RE: Development Application seeking a Development Permit for a Material Change of Use & Reconfiguring of a Lot, Lot 5 BK157130, 174 Buchanan Creek Road, Operational works

RE: Daintree Microgrid Project – request for information, solar farm

Figure 8 CGF General Layout (excl Solar Farm)

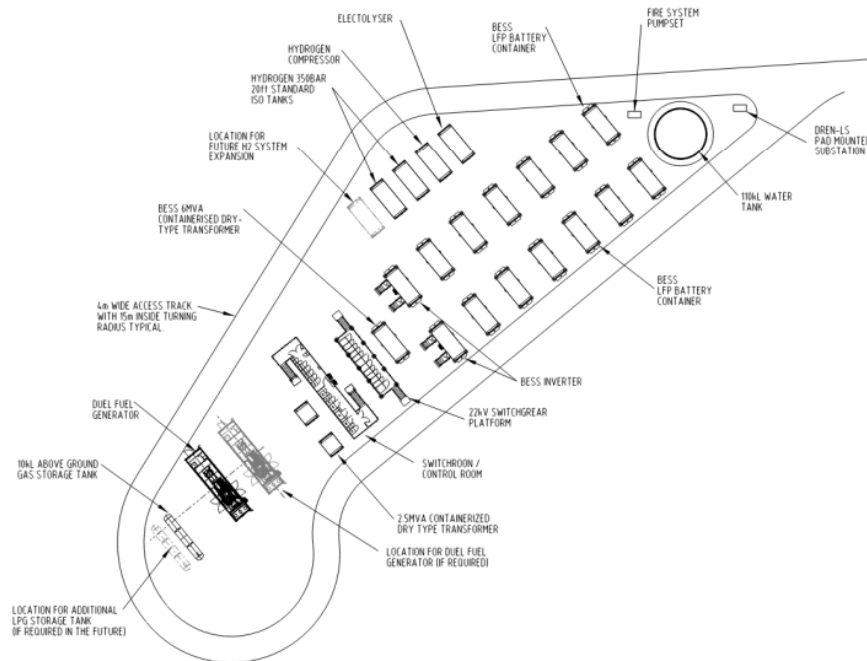
1. *Provide a fire management plan for the Daintree Microgrid in the event of fire or fire hazard. In particular, detail the measures in place for the Lithium Iron Phosphate (LiFePO₄) cells, hydrogen and LPG storage components of the generation plant.*

Layout of the Central Generation Facility Islanded by Accessway

All plant as shown above have clearances at or exceeding requirements of the relevant standards noted.
